# COMBINED LINWOOD/EASTERN INTERCHANGE & US 50/RED BANK INTERCHANGE FOCUS AREA ADVISORY COMMITTEE MEETING NOTES

EASTERN CORRIDOR SEGMENTS II AND III (PID 86462)

## MEETING #3 NOTES

Sept. 7, 2018

**Figure X-4D**  
EXTEND WOOSTER TO TIE  
DIRECTLY INTO RED BANK ROAD

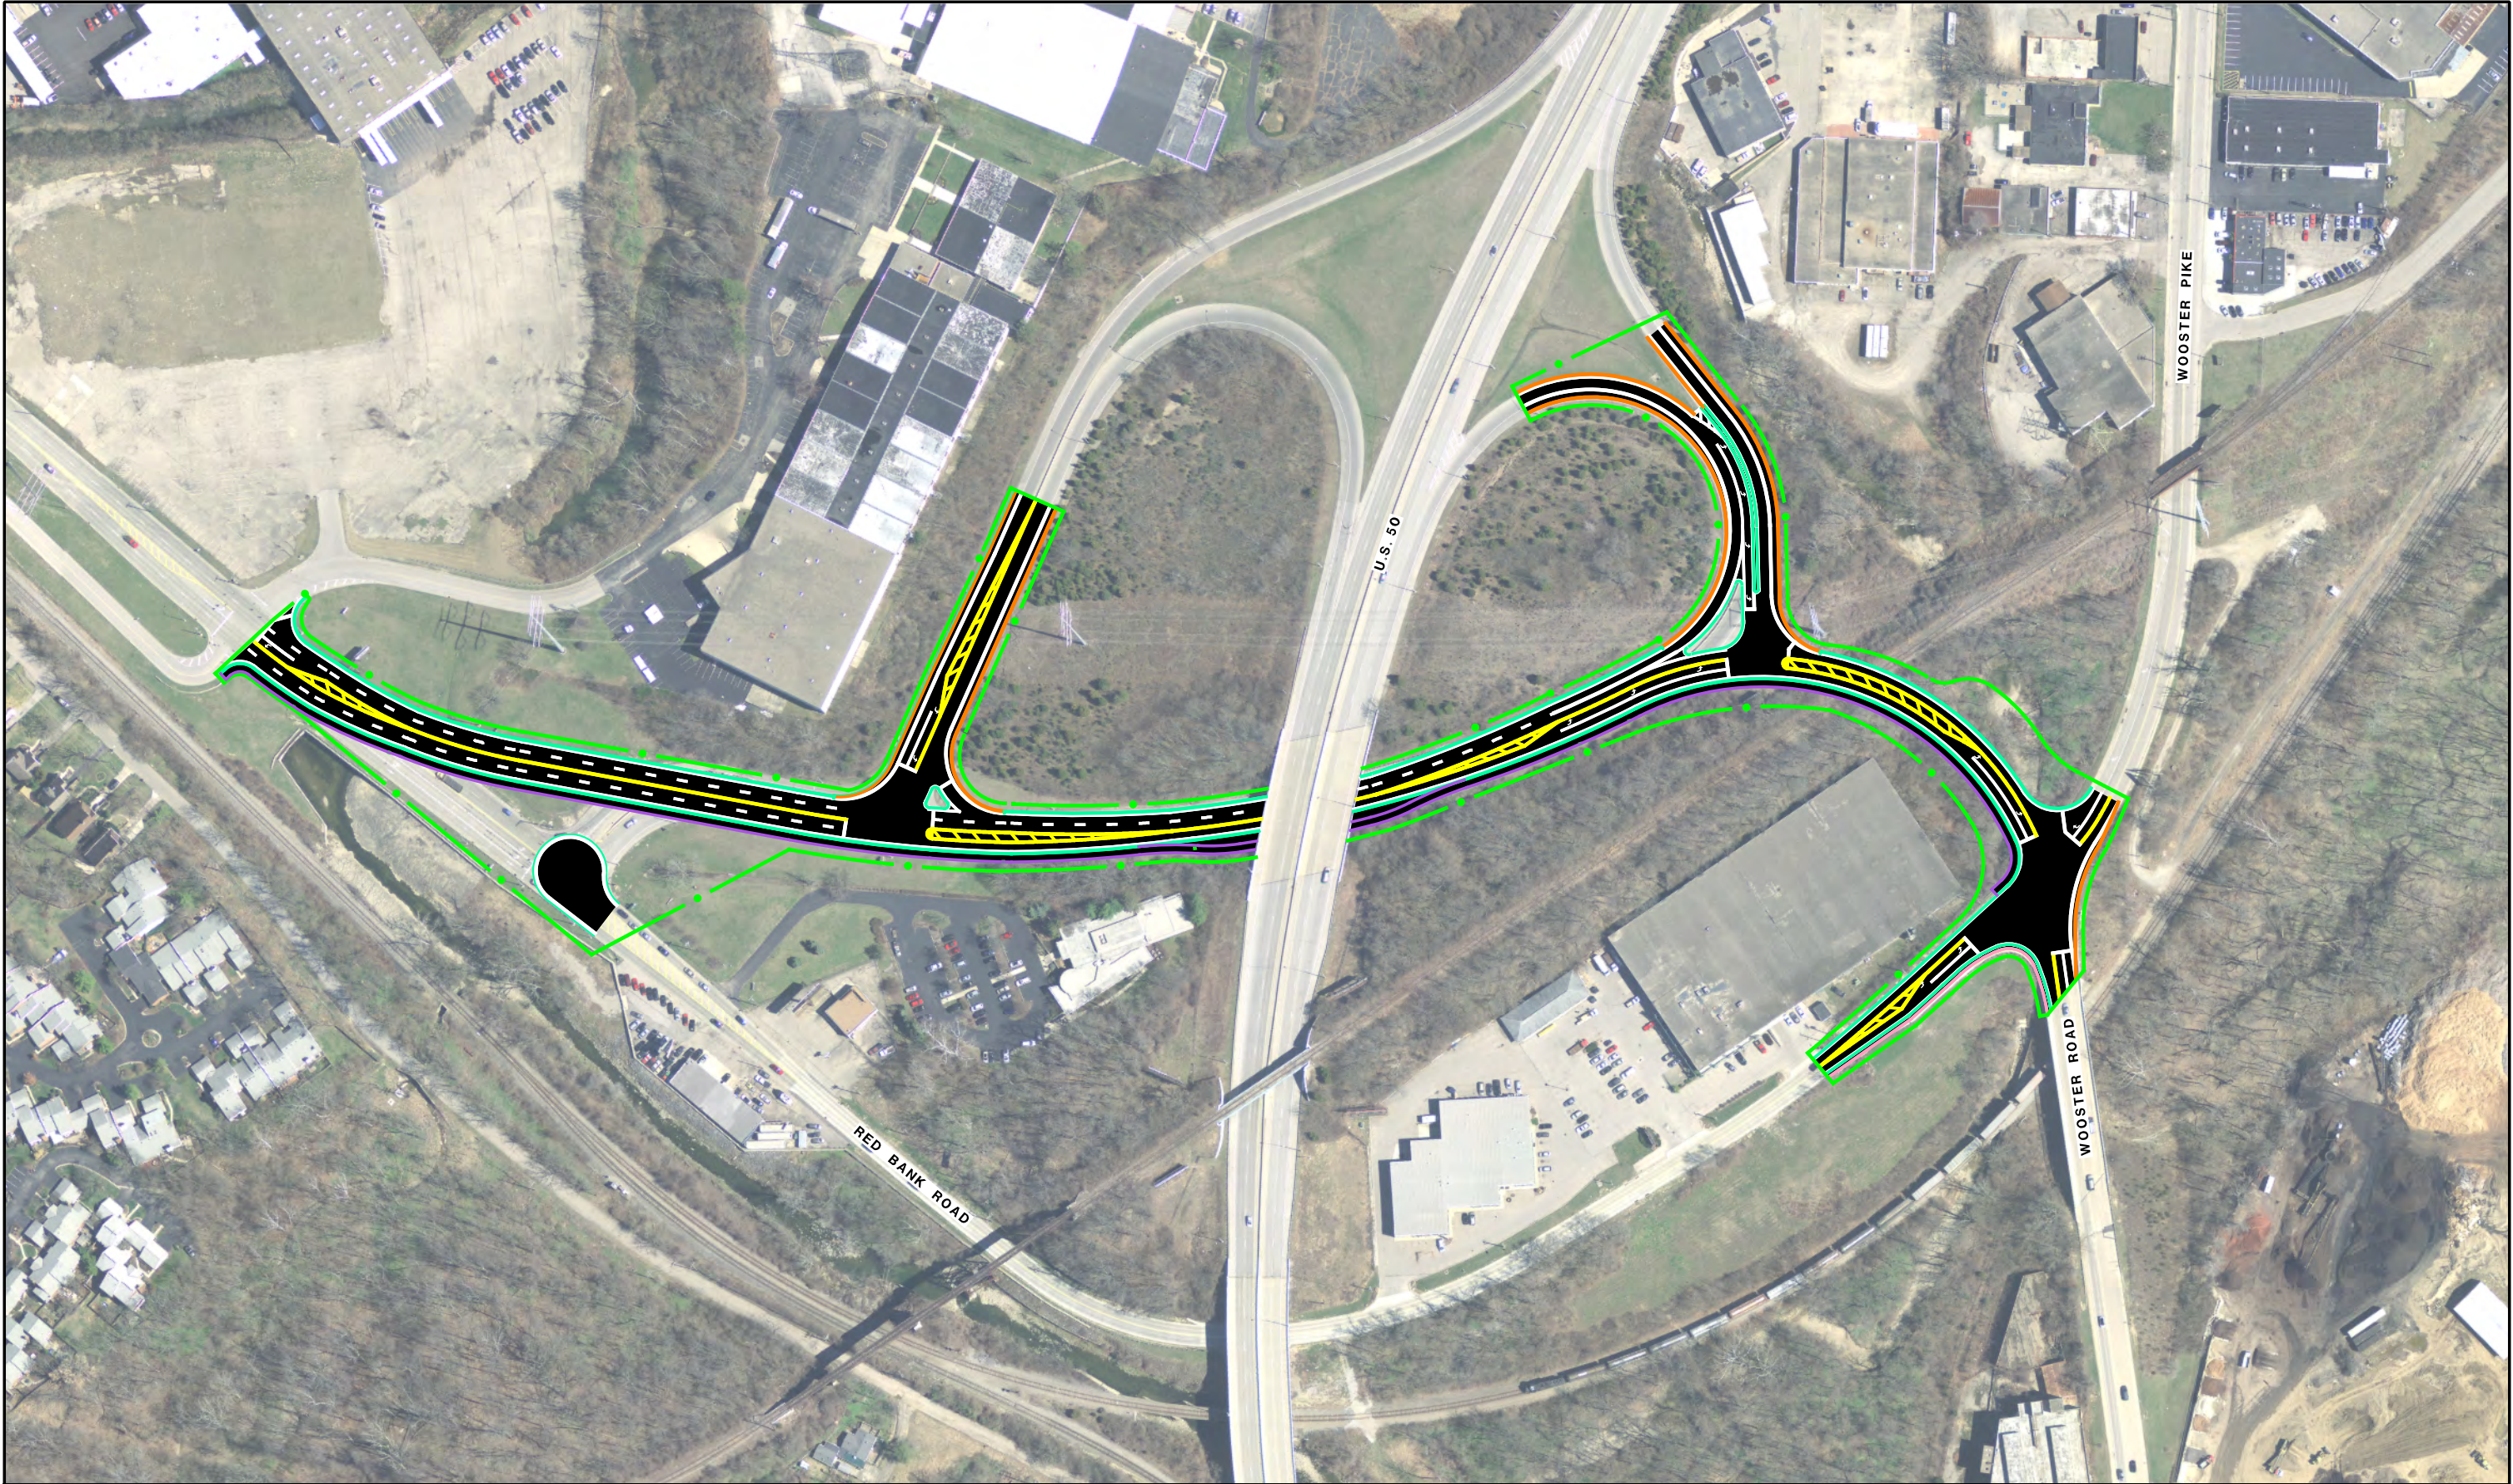
- Mariemont does not support creating a cul-de-sac on Red Bank and eliminating the current intersection of Colbank and Redbank. Multiple traffic routes currently provide options for vehicle and truck traffic from businesses.

- Mariemont expressed concern about making the current Red Bank/Colbank intersection a cul-de-sac. Redundancy is desired to provide two routes for trucks to Red Bank Road.

- No further study. Concept X-4d-1 (roundabout at Wooster intersection) appears to be a better option and allows for a better shared-use path connection (the roundabout allows a shared-use path to utilize existing width on the bridge).

**Figure I-16B**  
**ROUNDBOUT AT MEADOWLARK LANE  
 AND U.S. 50 INTERSECTION**

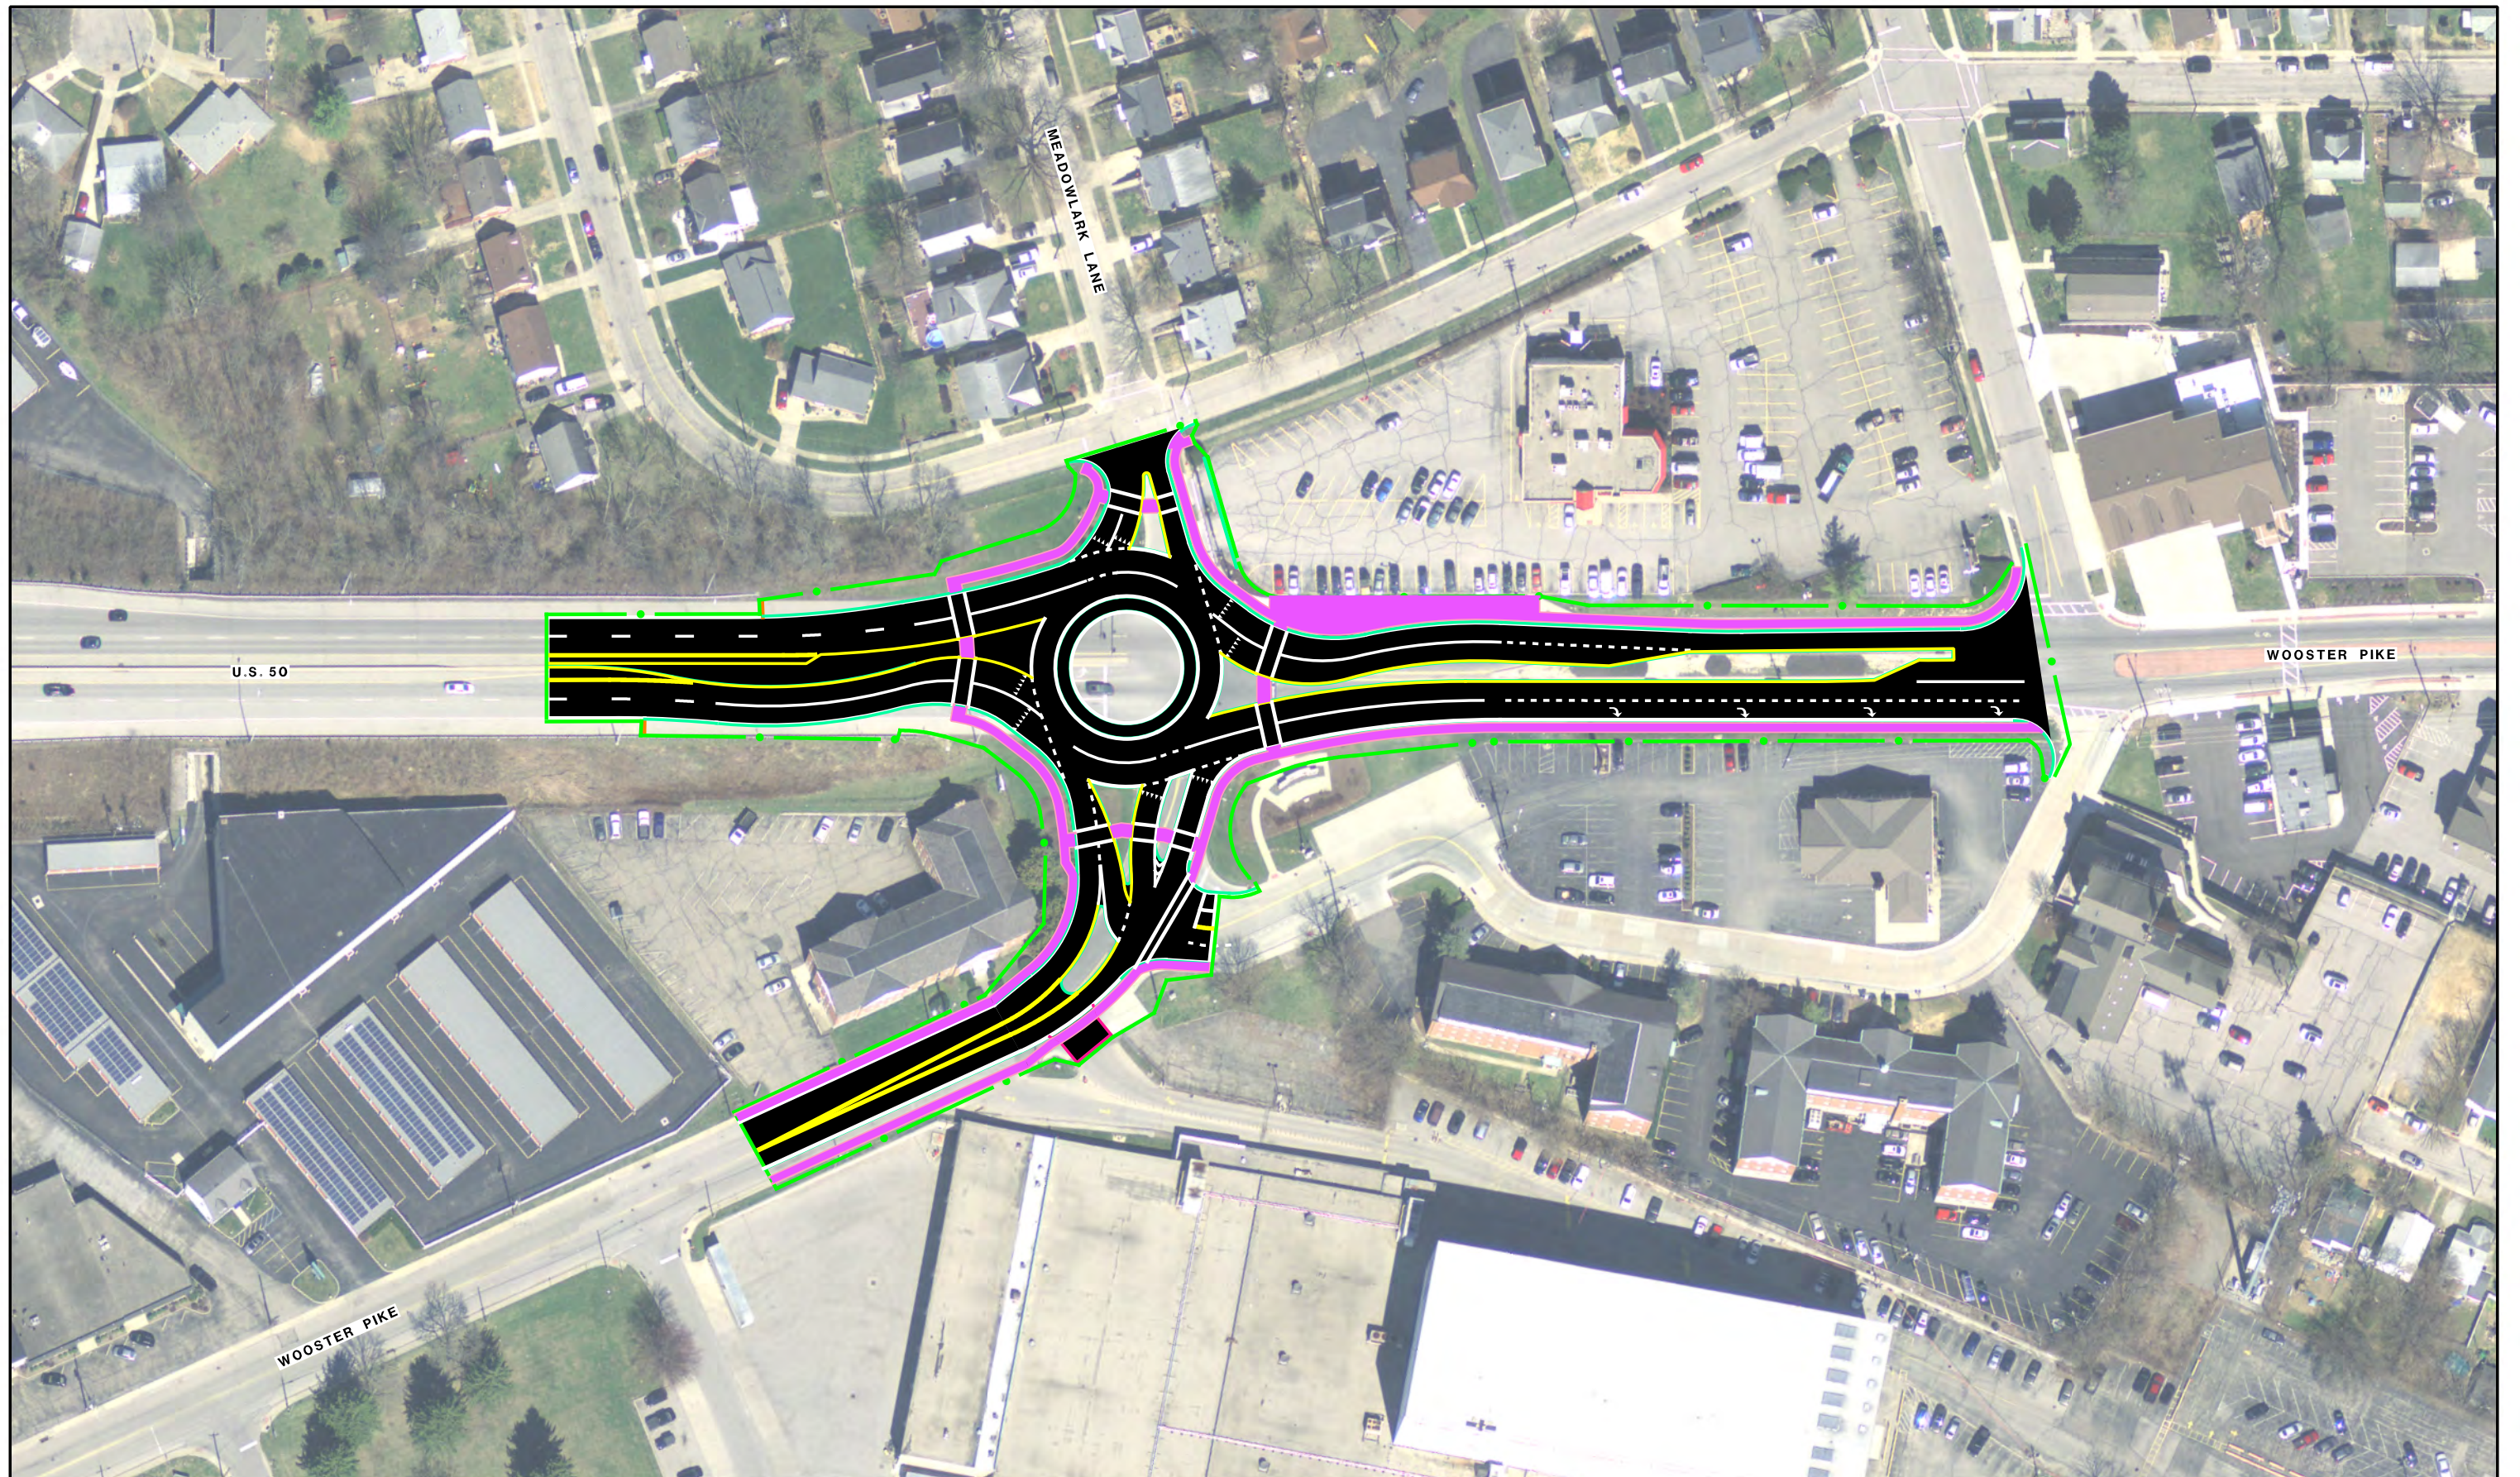
- Verify roundabout shown is drawn to scale and that it will accommodate life safety and semi-truck traffic. Have all other options for this intersection been eliminated? Additional input from Mariemont businesses will be needed to address other potential concerns. The Haney Building (formerly Streitman Biscuit Company) and the Mariemont Industrial District are listed on the National Registry of Historic Places, and Section 106 shall be incorporated into the process.

- The committee discussed whether the traffic signal at Watterson could back drivers up into the roundabout. Traffic simulations show that for 95 percent of queues, this would not be an issue. However, given signal timing adjustments and the fact that closures on Wooster Pike have resulted in more traffic on US 50, these simulations will need to be re-evaluated once Wooster reopens to ensure that is still the case
- The committee discussed whether it would be simpler to reconfigure the lanes in front of the Mainliner and eliminate the curb bump-outs to allow for two lanes of westbound traffic. This could provide a more immediate solution, with the roundabout phased in later. Long term, however, the roundabout offers other benefits (slower travel speeds, increased safety) and could serve as a gateway to Fairfax.

- Advance for public consideration.
